Request to adopt the Southeast Community Plan: 2004 Update

Adopt the Southeast Community Plan: 2004 Update.

Metro Planning Commission Meeting of 7/22/04

1. Trousdale Drive

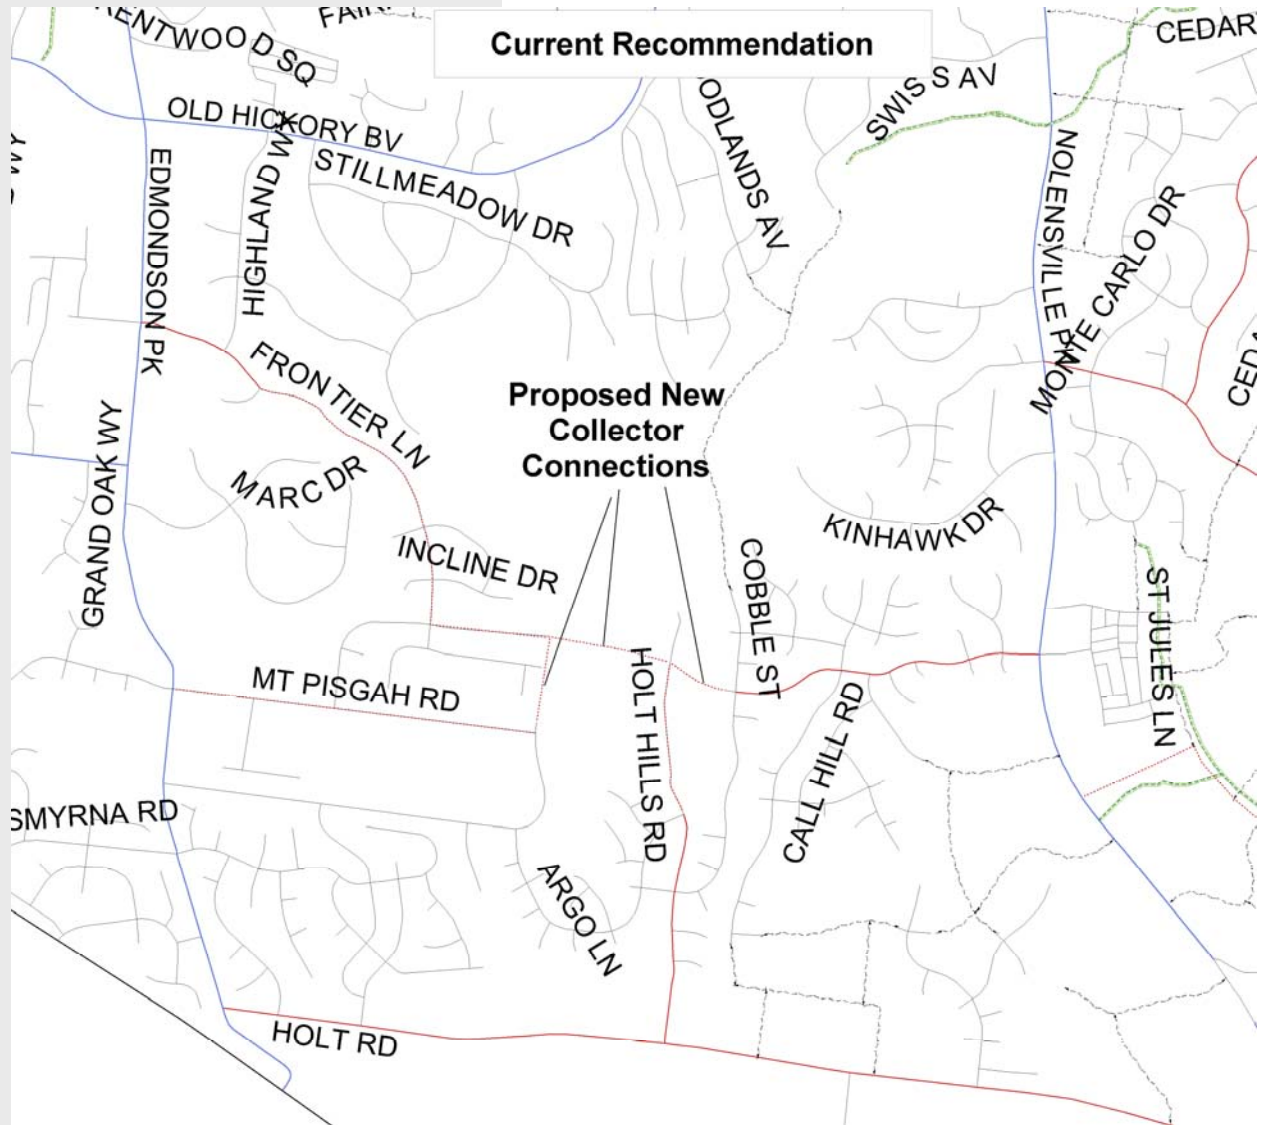
1. Elimination of proposed connection of Trousdale Drive to Old Hickory Boulevard: Staff has learned that all options for making this connection have now been eliminated because the owners of property where right-of-way would need to be acquired are unwilling to permit Trousdale to be extended through their land.

2. Frontier Lane-Christiansted Lane-Mt. Pisgah Road to Holt Hills Road and Bradford Hills Drive:

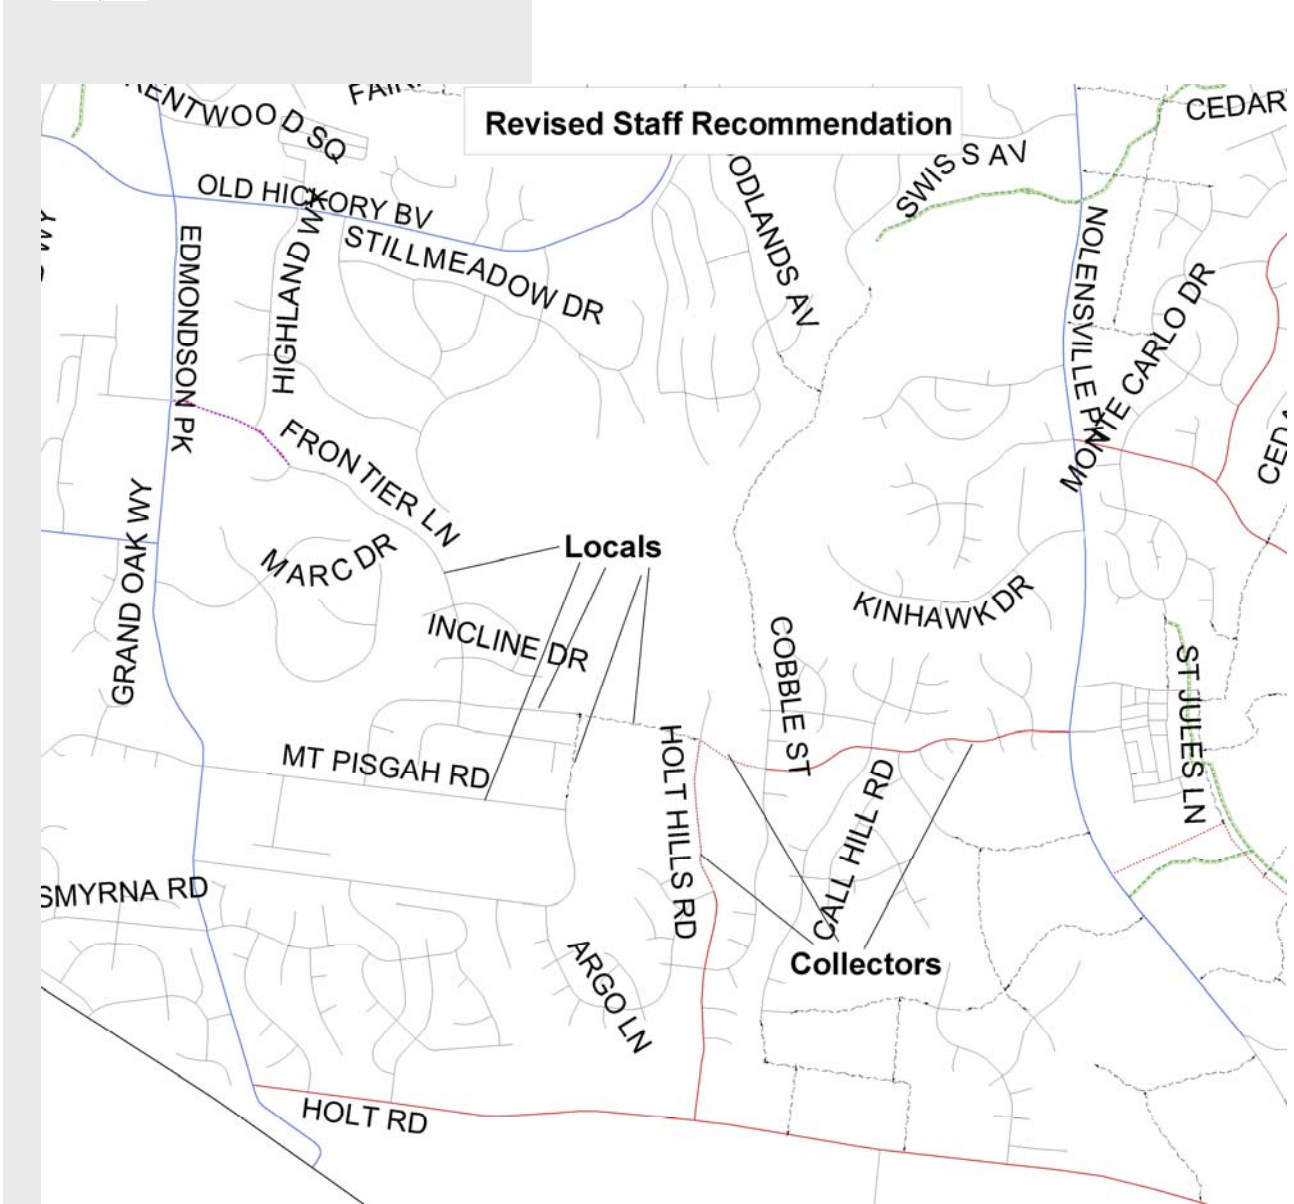
2. Change proposed collector street system involving Frontier Lane, Christiansted Lane, Mt. Pisgah Road, and proposed new connections to Holt Hills Road and Mt. Pisgah Road to a local street system. In response to local opposition to the connection of Christiansted Lane to Holt Hills Road, Bradford Hills Drive, and Mt. Pisgah Road, staff has done some additional investigation and discussion and come to the conclusion that while these remain important connections to serve this still-growing area, it would be better for the connections to be local connections rather than collectors. Christiansted Lane and Mt. Pisgah Road were built as local streets and it would be best to make the connections into them local streets as well. This would enable traffic calming measures to be employed, preferably in the original design of the new streets.
